Product Change Notification Number: PCN262401	Date: 12.06.2026
--	-------------------------

Title: SHT85 - FilterMembraneChange
--

Product Identification: SHT85 (3.000.074)
--

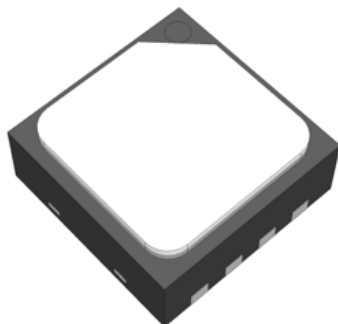
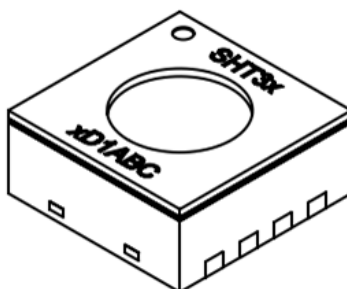
Change Description:
Transition of the sensor filter membrane material from PTFE (Polytetrafluoroethylene) to PI (Polyimide). This change allows the implementation of highly scalable manufacturing processes and ensures our capacity to meet growing market demand and enhances the resilience of our supply chain.

- Function and performance: **Unchanged**. The sensor specification, accuracy and response time remain identical. The PI membrane is IP68 certified and provides equivalent protection against dust and particles.
- Fit: Full backward compatibility with existing PCB layouts.
- Appearance: The sensor will have distinct visual appearance due to the new membrane material (see image comparison below).

The sensing element of SHT85 will change the appearance.
